PANEL NAME	415V ACDB EXTENSION
CLIENT	 BIHAR STATE POWER TRANSMISSION COMPANY LIMITED(BSPTCL)
CONTRACTOR	 M/S. ABN TOWER AND TRANSMISSION PRIVATE LIMITED
PROJECT.	DESIGN, MANUFACTURE, TESTING AT MANUFACTURE'S WORKS AND DELIVERY OF EQUIPMENTS REQUIRED FOR CONSTRUCTION OF 2X50MVA, 132/33KV GSS BHOHEY (DIST. GOPALGANJ) INCLUDING RESIDENTIAL QUARTER WITH CONSTRUCTION OF ITS ASSOCIATED 02NOS. 132KV LINE BAYS AT GSS HATHUA & CONSTRUCTION OF ITS ASSOCIATED 132KV D/C BHOHEY-HATHUA TR. LINE WITH ACSR PANTHER CONDUCTOR (LINE LENGTH-60RKM) ON TURNKEY BASIS.
PO NO:	ABN/24-25/BSPTCL/10/PO-160
NIT No.	10/PR/BSPTCL/2023
QTY:	1No.

PROJECT : 132/33KV GSS BHOHEY (DIST. GOPALGANJ) , BIHAR

NAME	DATE	TITLE :
DRAWN GANESH	08.08.2024	415V ACDB EXTENSION
CHECKED GANESH	08.08.2024	TITLE SHEET
APPROVED

Sub: Submission of revised drawing & GTP of LT Switchgear of M/s Asian Switchgear Pvt. Ltd. for approval.

TITLE:
220V DCDB-EXTENSION
GENERAL ARRANGEMENT DRAWING

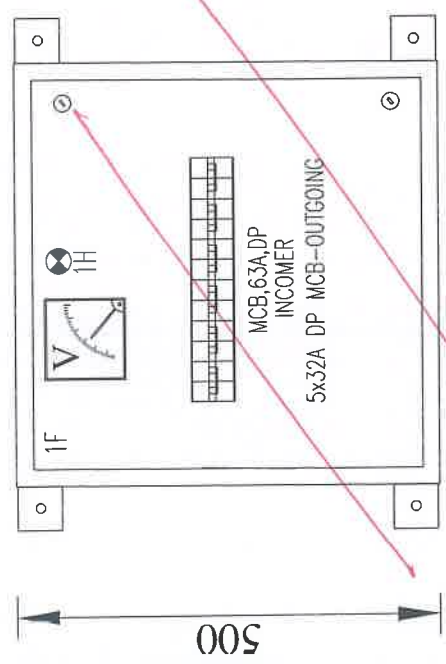
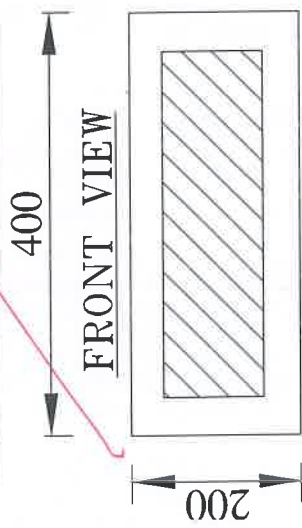
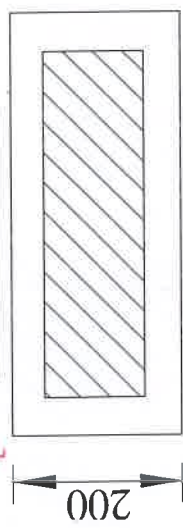
Should be revised as per comments.

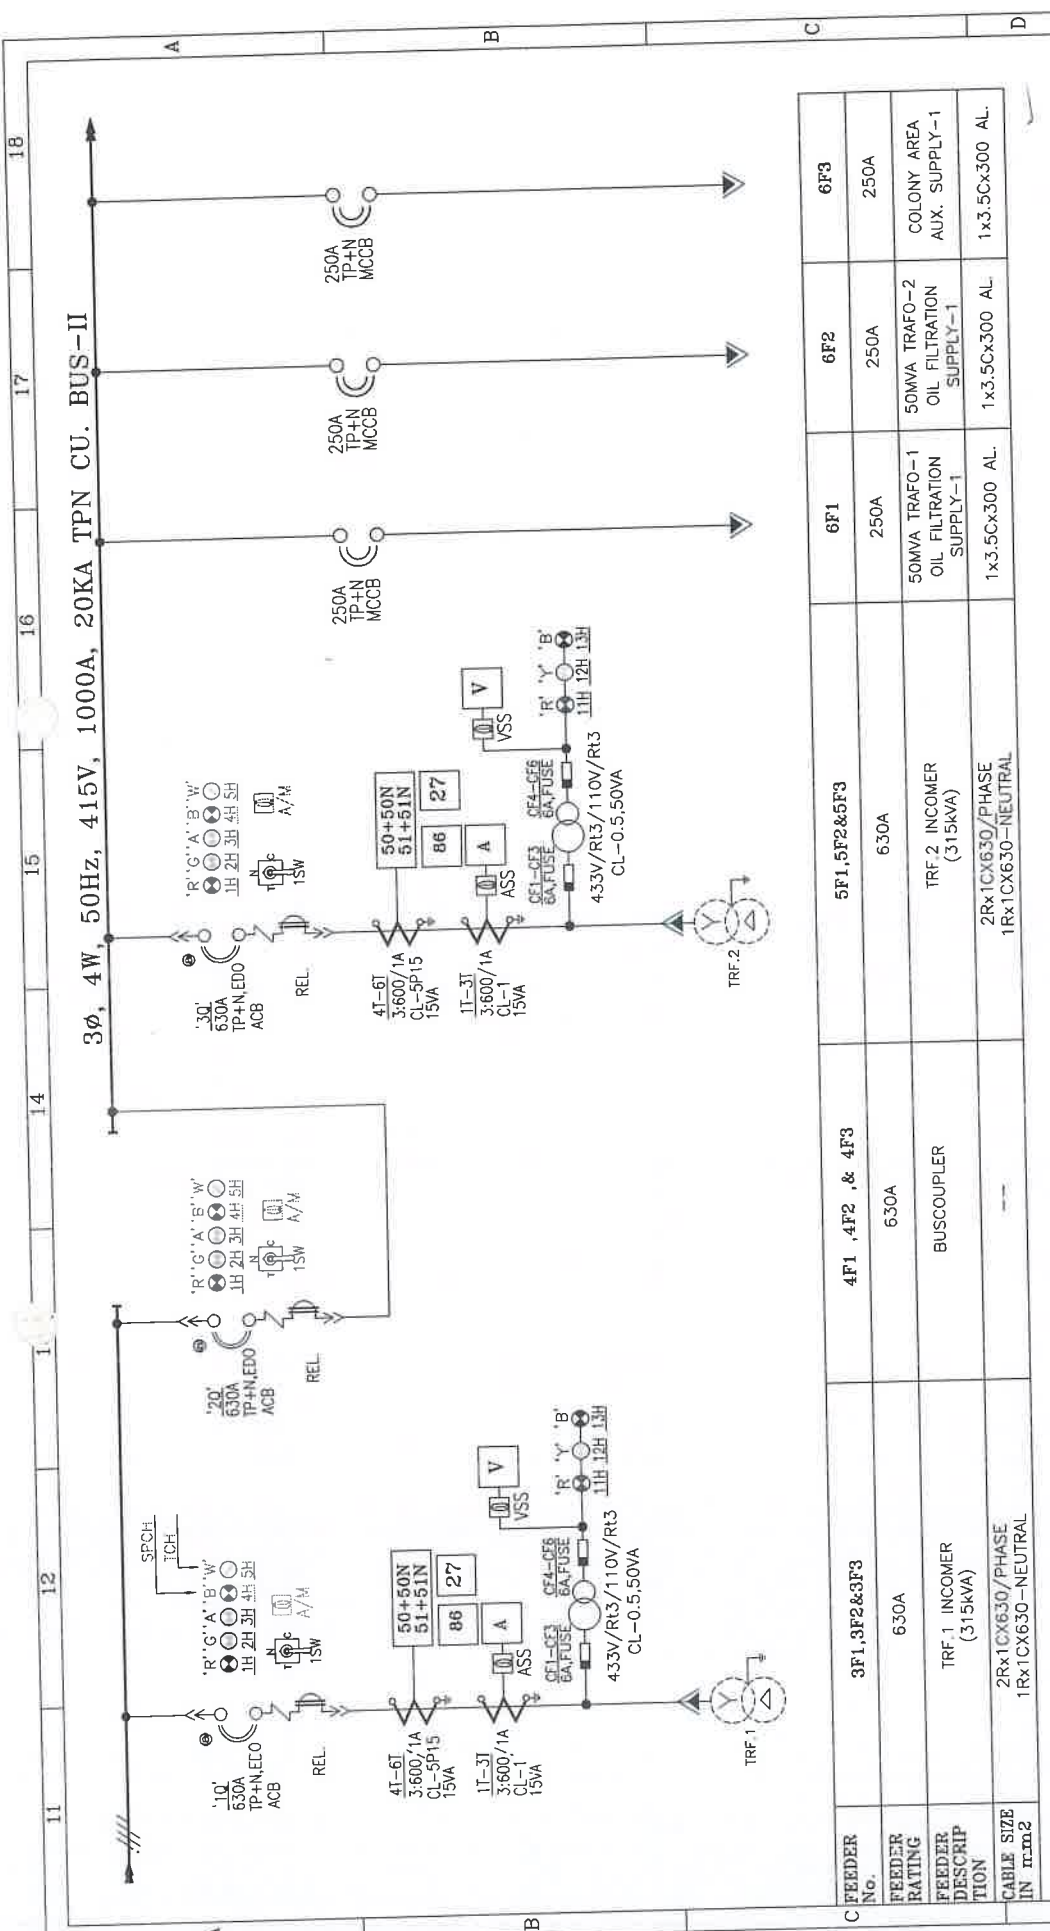
Same comment as in Sheet 04 of 14 (IF4)

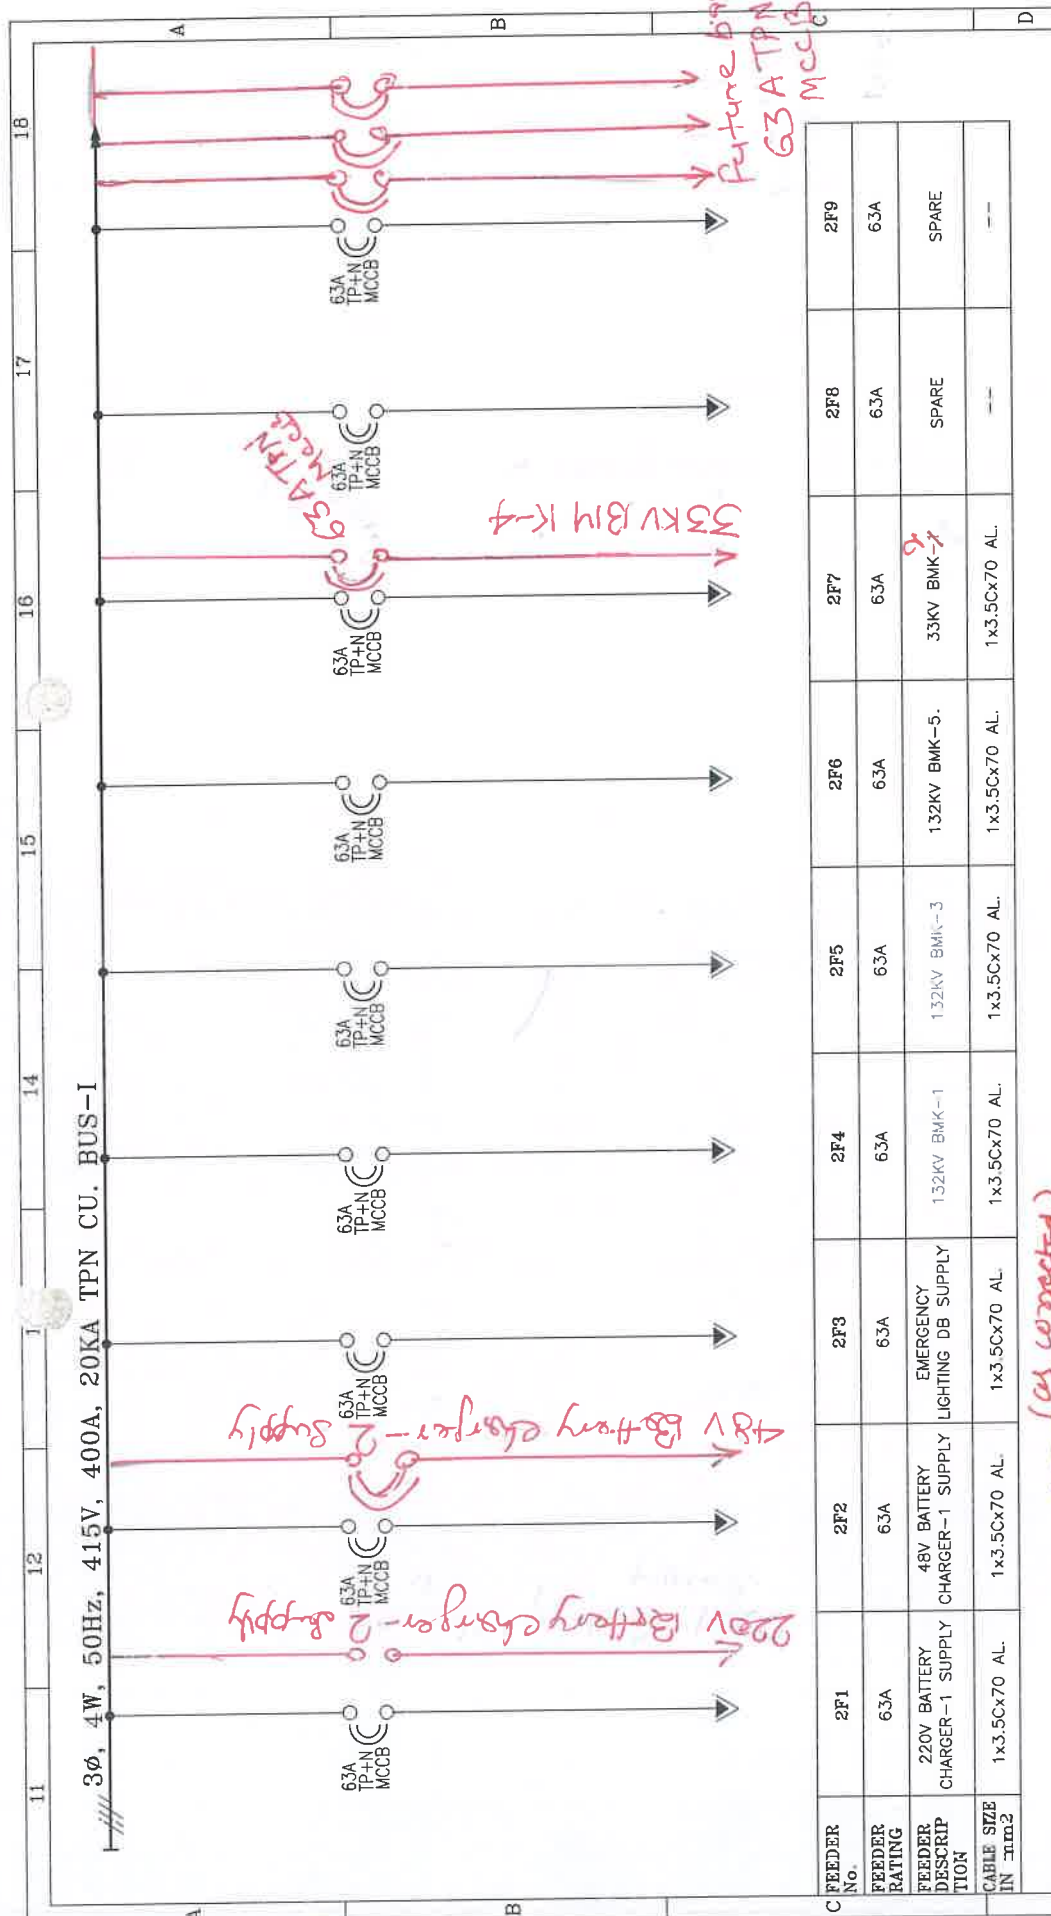
It Shall be modified as per comments

TYPICAL FOR LIGHTING TRF.-2 I/C

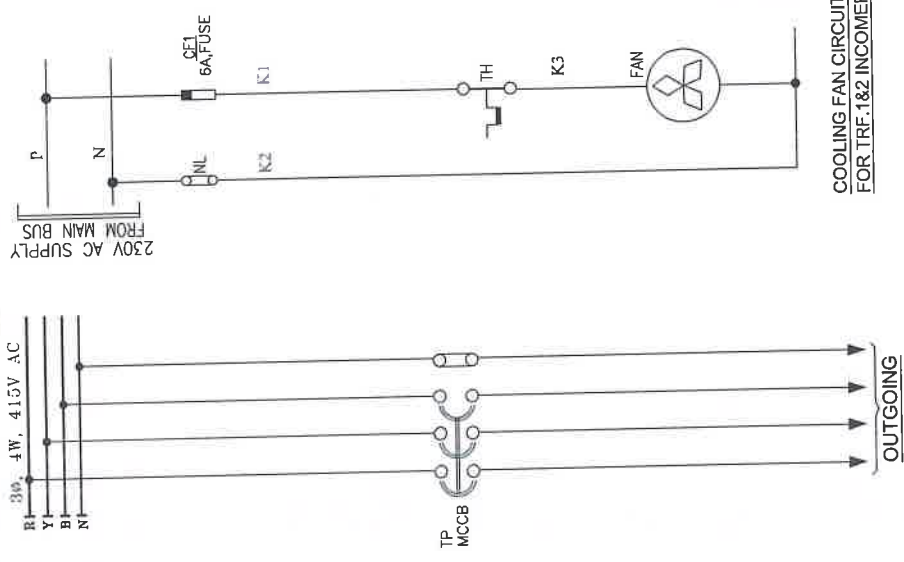
Identical for
in corner
both

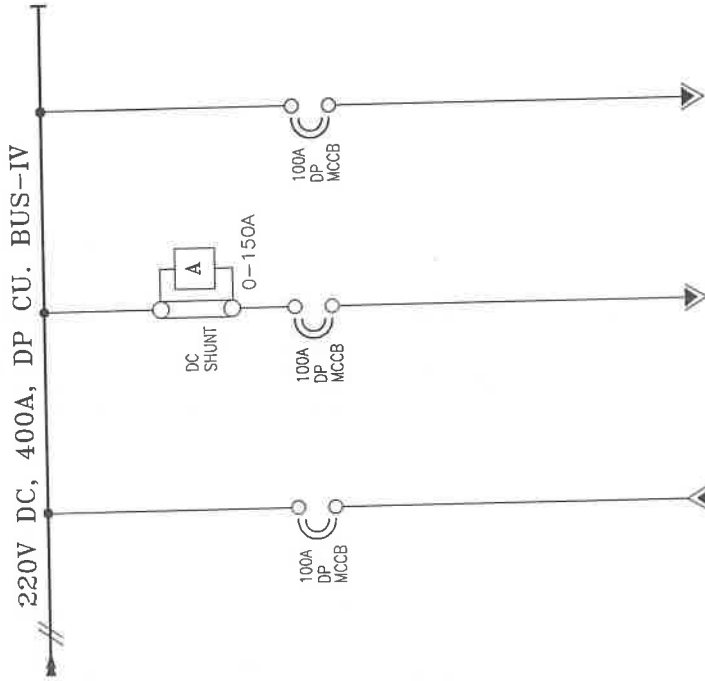
Separate NCB
 feeders to
 Trade-1
 & Trade-2
 common supply

Separate
 NCB feeders
 for Trade-1
 & Trade-2
